MIL-F-8975B
AMENDMENT 4
7 DECEMBER 1998
SUPERSEDING
AMENDMENT 3
31 May 1994

MILITARY SPECIFICATION

FASTENER, BLIND, HIGH STRENGTH, INSTALLATION FORMED
CORROSION RESISTANT STEEL, HEAT RESISTANT STEEL AND TITANIUM
GENERAL SPECIFICATION FOR

This amendment forms a part of Military Specification MIL-F-8975, dated 29 September 1982, and is approved for use by all departments and agencies of the Department of Defense

**FIGURE 1. Visual inspection illustration, Type I.**

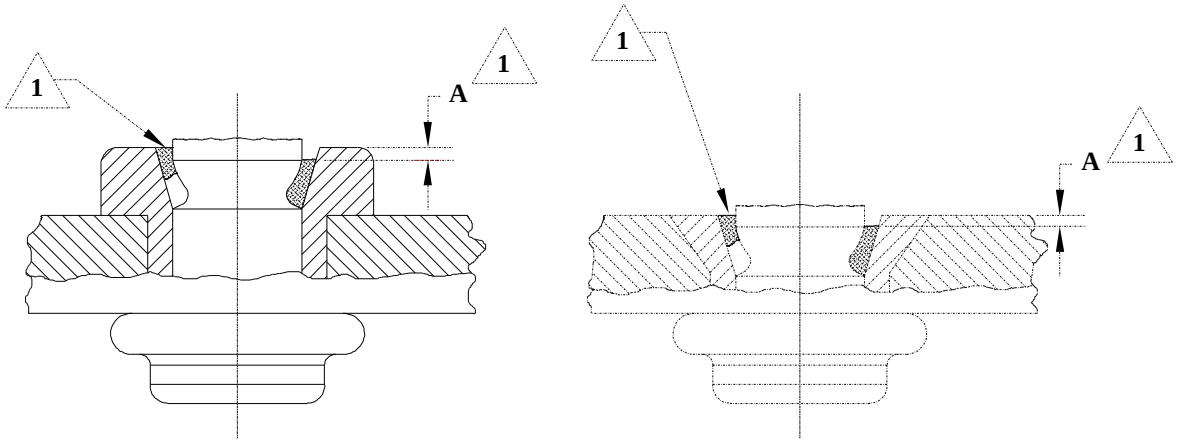
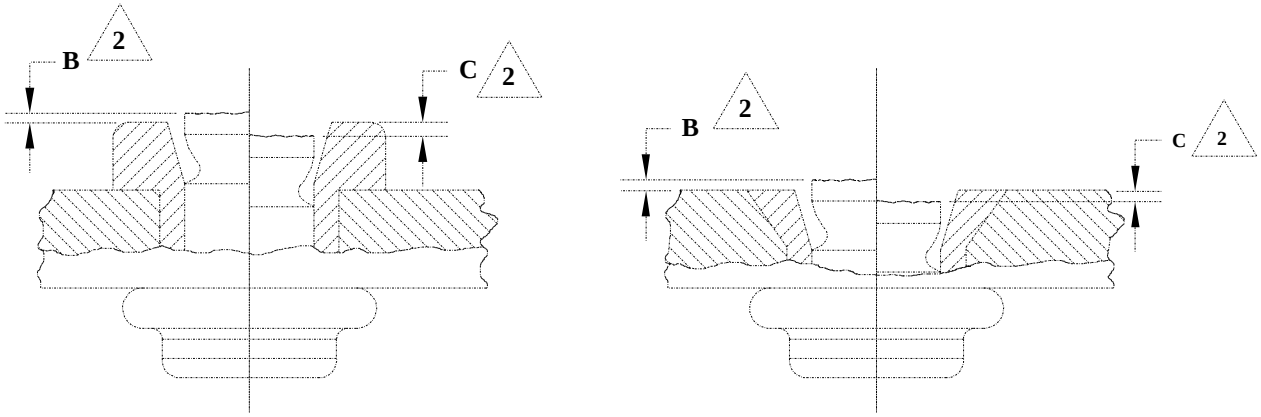
Figure 1. Delete in its entirety and substitute:

**INSPECTION OF**
**LOCKING COLLAR POSITION**

1 **Collar to be flush or below top of sleeve head.**

**INSPECTION OF**
**SPINDLE POSITION**

2 **Maximum allowable distance above or below fastener head to nominal pin fracture surface.**
